U. S. NUCLEAR REGULATORY COMMISSION

Report No. 50-334/85-03  
Docket No. 50-334 License No. DPR-66  
Licensee: Duquesne Light Company  
One Oxford Center  
301 Grant Street  
Pittsburgh, PA 15279

Facility Name: Beaver Valley Power Station, Unit 1

Inspection Summary: Inspection No. 50-334/85-03 on January 8 - 15, 1985.

FIGURE 1

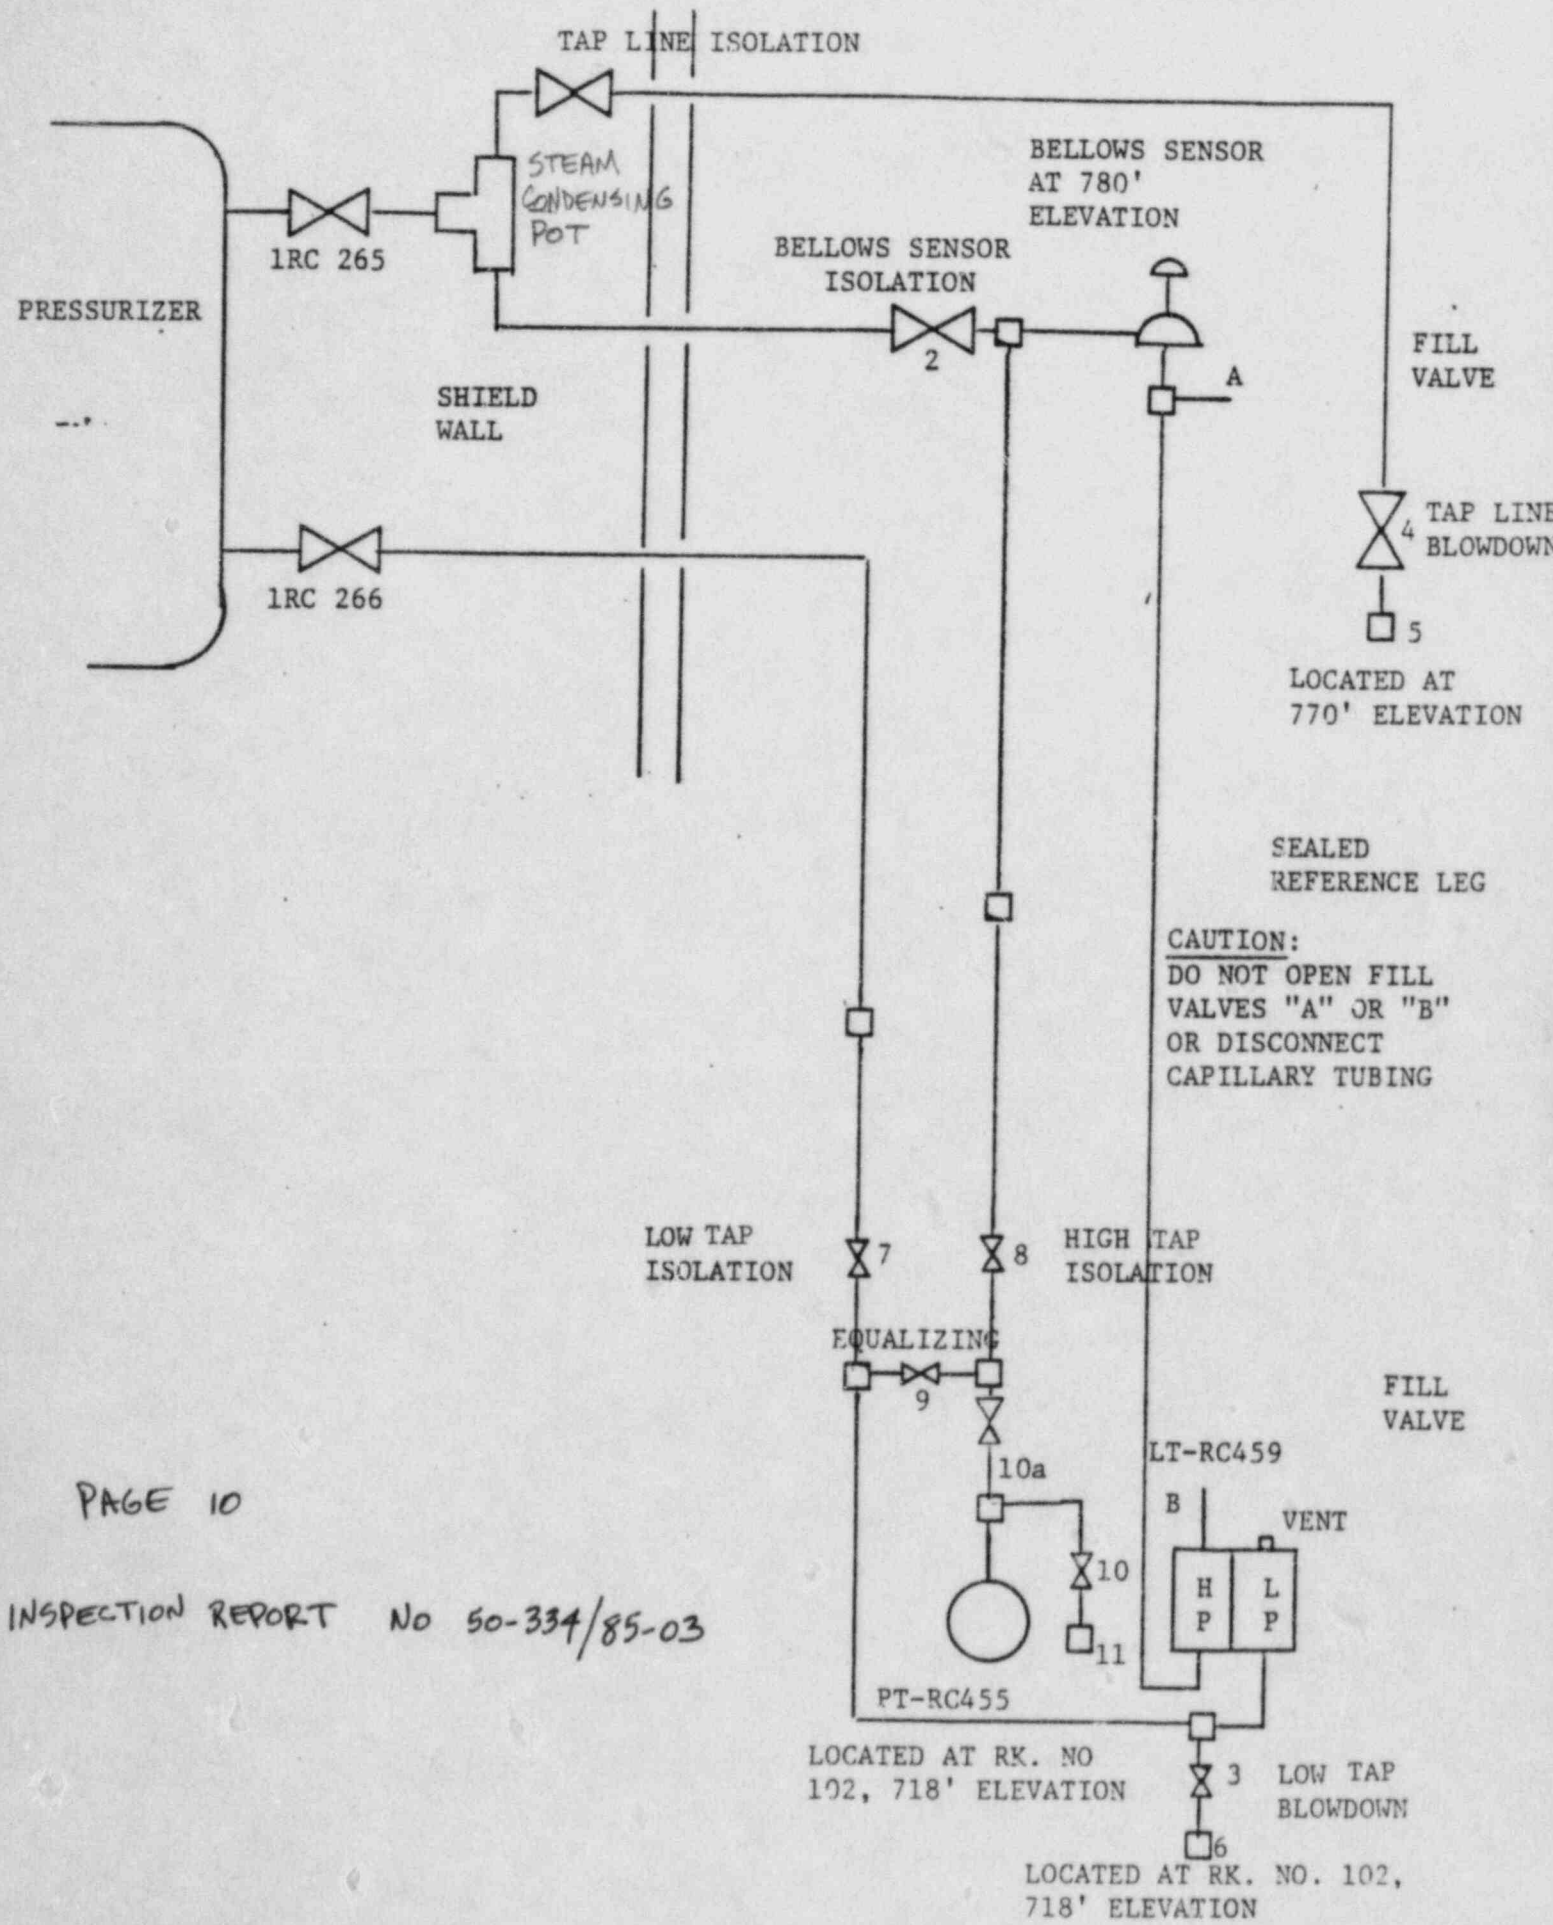
Instrument and Control engineers informed the inspector that with a total water drop of 7 inches as was expected to occur when water is drained from the condensate pot to the bellows sensor, over a total span of about 200 inches on hot calibration, a total level increase of 3-1/2 percent was expected. After several occasions where the observed increase was greater, the licensee initiated an investigation during the fourth refueling outage. Calculations indicated that for a channel response of up to 7 percent full scale, the level drop between the condensate pot and bellows sensor would have to be about 13 inches. A hand-over-hand walkdown of the system identified that only the 7 inch drop between the condensate pot and the 90° elbow had been taken into account in the original A-E calibration procedure. The level change due to the slope of the piping running from the condensate pot to the bellows sensor had not been included.

All three pressurizer level channel trip setpoints were set below Technical Specification 2.2.1, Reactor Trip System Instrumentation Setpoints, allowable ranges since plant startup because of a common mode error in developing calibration procedures that did not accurately reflect elevation changes between the condensate pot and the bellows sensor. The calibration procedure development and review process did not identify this deficiency.

Technical Specification 2.2.1 requires that when a reactor trip system instrumentation setpoint is less conservative than the value shown in the Allowable Values Column of Table 2.2-1, that the channel be declared inoperable and the appropriate action statement of Specification 3.3.1.1 be applied until the channel is restored to operable status. Table 2.2-1 specifies an allowable value for the pressurizer water level high trip setpoint of less than or equal to 93 percent of instrument span. Table 3.3-1, Reactor Trip System Instrumentation, requires that when one pressurizer water level channel is inoperable, that the inoperable channel be placed in the trip position within one hour; and continued operation is permitted until the performance of the next channel functional test is required. The failure to set the three pressurizer level setpoints within the values specified is an apparent violation (85-03-01) of Technical Specification 2.2, Limiting Safety System Settings.

The Supervisor of Instrumentation and Control informed the inspector that revisions to the test procedures (MSP 6.41, -42, -43, Pressurizer Level Protection Channel Calibration) have been completed. Review of plant level instrumentation systems indicate that a bellows sensor system was only employed in the pressurizer level channels.
